Reliability Analysis Update

Wenzheng Qiu
Sub Regional RTEP Committee – PJM West

May16, 2025

B3361: Originally presented in 10/15/2021 and 11/19/2021 W-SRRTEP

Project System Electrical Diagram (original Scope)

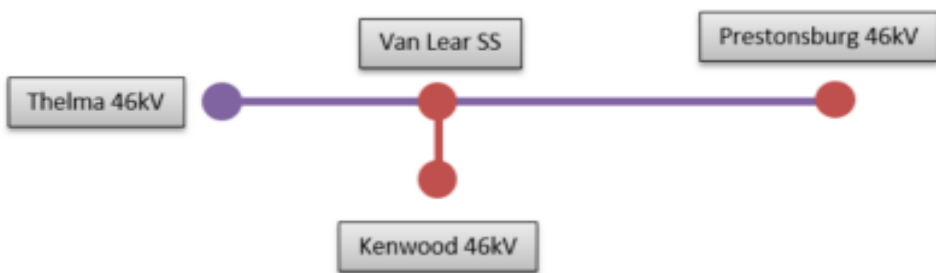
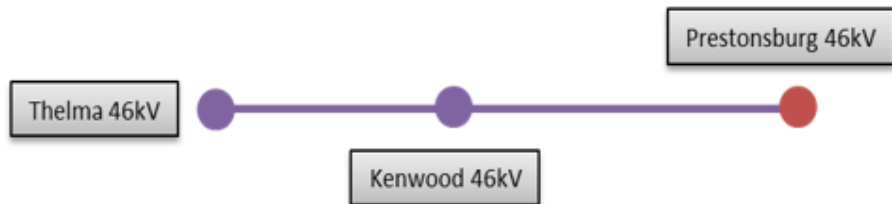
Rebuild Prestonsburg - Thelma 46kV circuit **connecting though Kenwood station**, approximately **44 12.7** miles. Retire Jenny Wiley SS **and Van Lear SS**. (B3361)

Reason for the scope change: The project is using new right of way that is closer to Kenwood station and will provide looped Transmission service to customers served from Kenwood station.

Reason for the cost increase: Labor and material costs are increasing for Transmission line construction. The difficult terrain in eastern Kentucky requires approximately 2 miles of access road for every 1 mile of line being built.
